MANDATORY SERVICE BULLETIN Z 50M/07a

1. **MODELS AFFECTED:** All Z 50M airplanes.
2. **SUBJECT:**
 - a) Sporadic occurrence of fatigue fracture in the eye thread shank of stabilizer left strut lower hinge.

Left and right stabilizer strut check

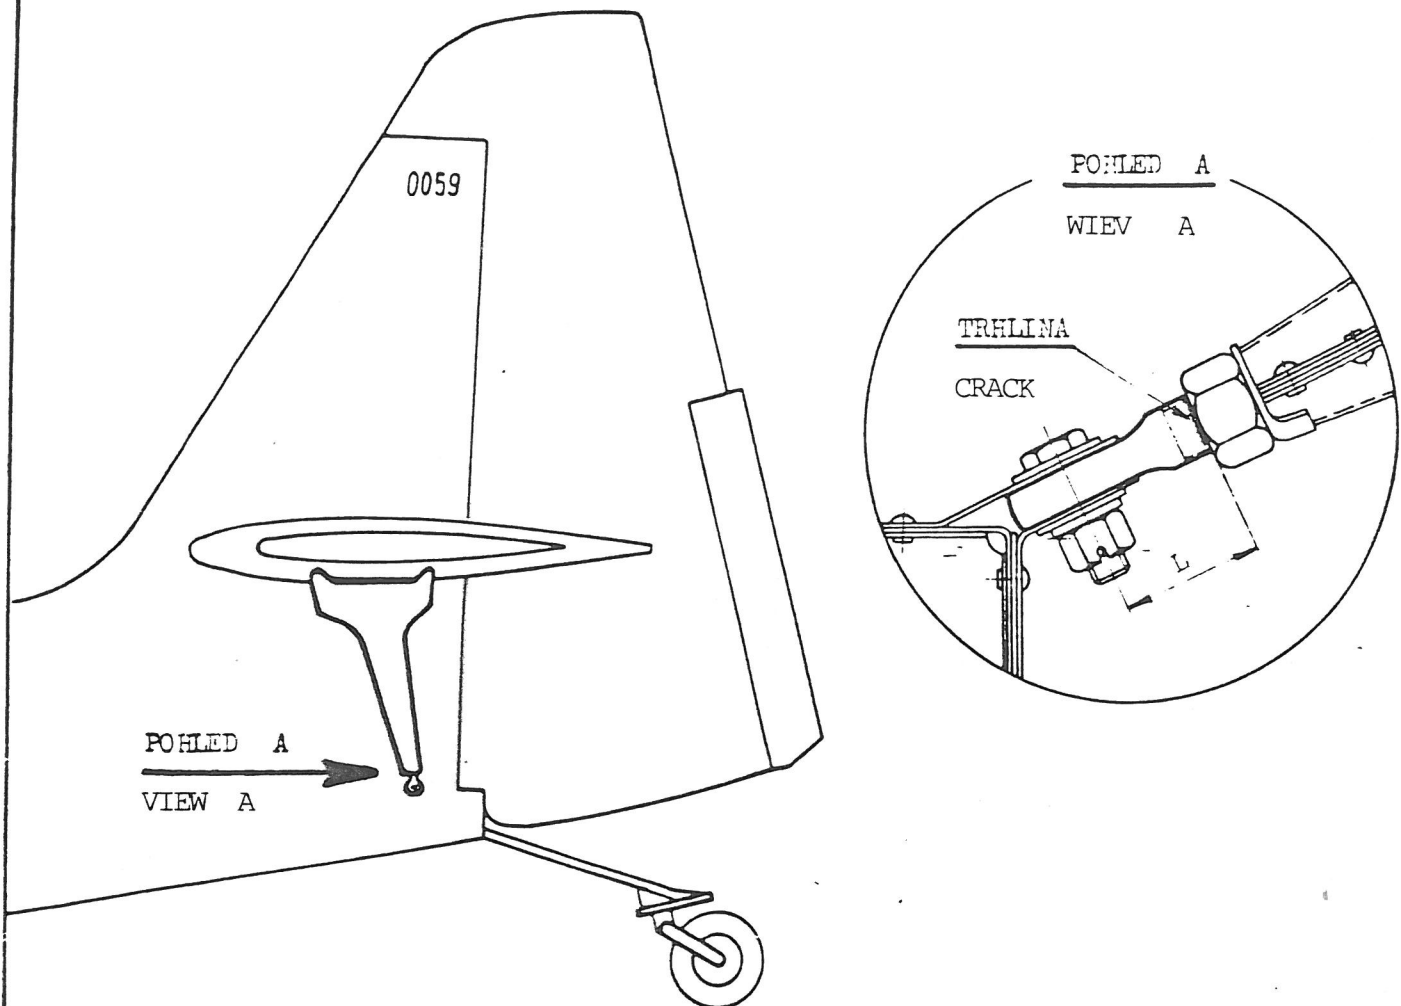
1. Check visually, by means of magnifying glass, the cracks occurrence in the strut skin at marked area (see figure) - pay increased attention to the left-side strut.
2. In case the skin is cracked, the strut must be replaced by new one.
Note: The ferry-flight in category "N" to the authorized repair station is permitted.
3. After the strut replacement the rigging of tail unit must be performed.

Check of the strut lower hinge eye
(Valid for S/N 0078, 0079, 0080)

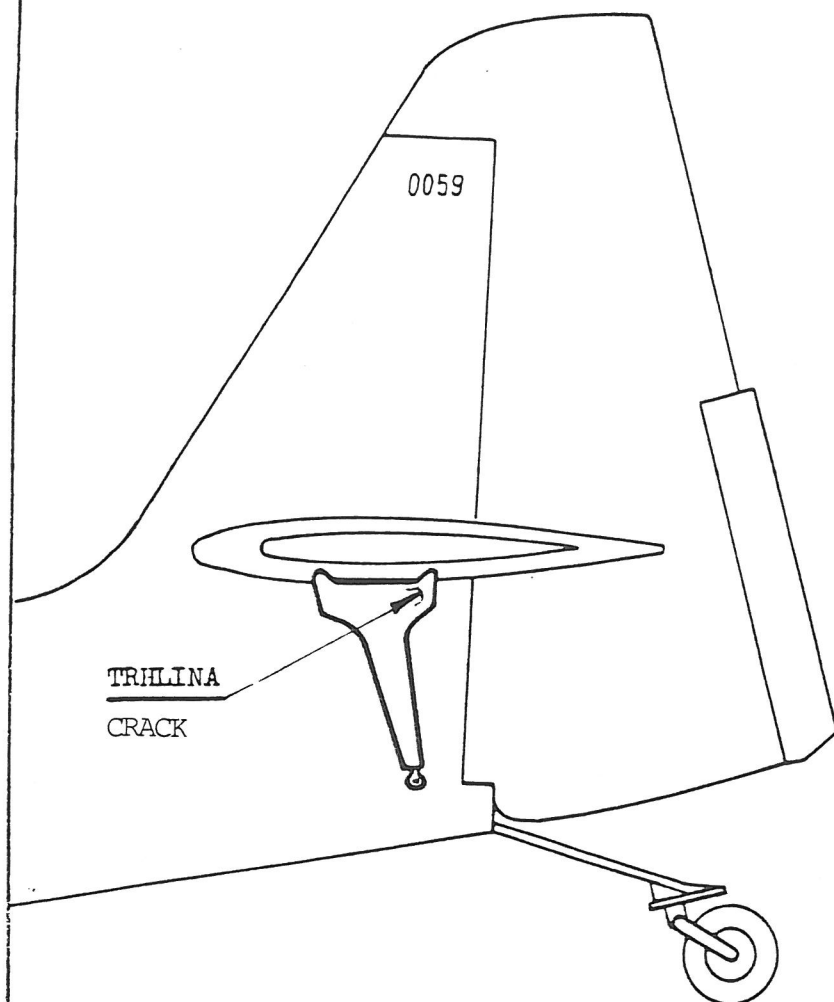
1. Disconnect the lower strut end from the hinge on fuselage.
2. Screw off the strut eye.
3. Check by non-destructive defectoscopic method the eye thread shank for cracks - place of possible crack occurrence, see view "A".
4. Screw the eye without crack to the strut, the cracked eye must be replaced.
5. Connect the strut with fuselage hinge.

Recommendation: Before screwing off the eye from strut, measure the dimension "L" (see "view A"), the distance must be kept during re-installation as the rigging of tail unit must not be changed. In case of any doubts perform the new rigging!

This recommendation is valid for eye replacement at airplanes S/N 0053, 0059 and 0060.
